Product Advisory (PA)

Subject: Change of the standard interior label of Renesas Electronics

Publication Date: December 1, 2022

Table 3 : Label Display Item

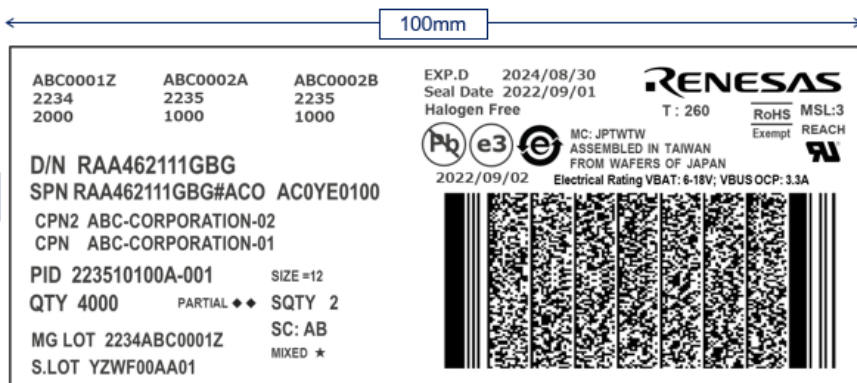
The new standard label after the change is as follows.

- Added Items
 - PID (Traceability Control)
 - S.LOT (Traceability Control) For Renesas Internal Use
 - Add RoHS / RoHS Exempt (Display RoHS or RoHS Exempt)
 - Add China RoHS (Display China RoHS Certified)
- Design Change Items
 - SPN (Orderable Parts No.)
 - CPN/CPN2 (Customer Parts No.)
 - Lot Combine Information
 - Country of Origin (Manufacturing Country Info.)
 - PCB On Board Reflow Rank (Peak Temperature)
 - MG LOT (Manufacturing Lot No.)

Gap Points Current and New / Renesas Japan (REL)

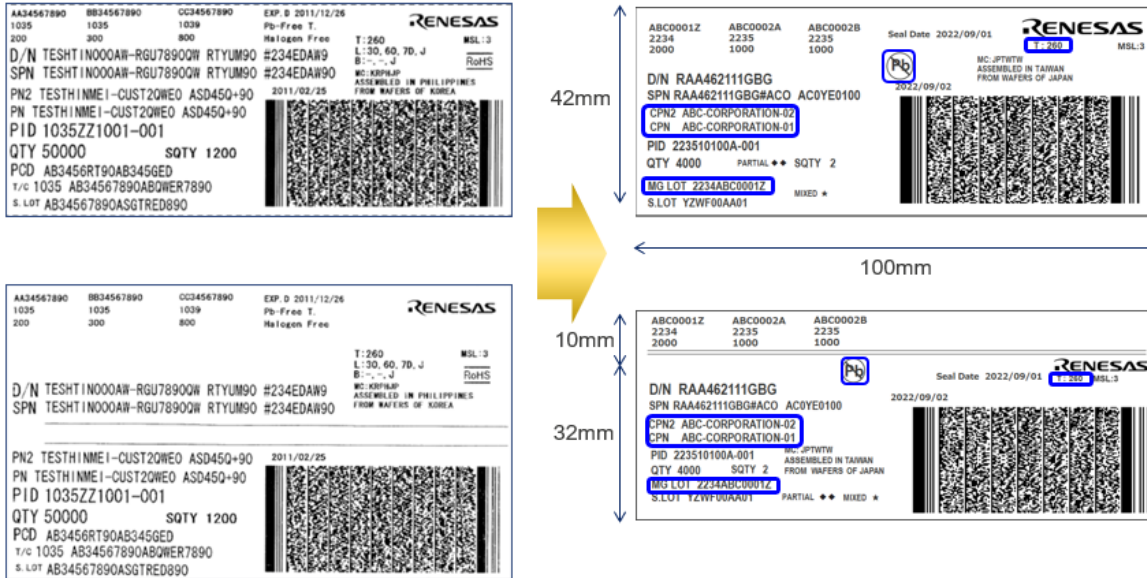
Comparison before and after change for legacy RENESAS products

- Design Change Items
- Pb-Free's Logo Mark
- PCB On Board Reflow Rank (Peak Temperature)
- Customer Parts No. (Display Name Change) PN/PN2 => CPN/CPN2
- MG LOT (Display Name Change) T/C => MG LOT
- PCN (Deleted Item)
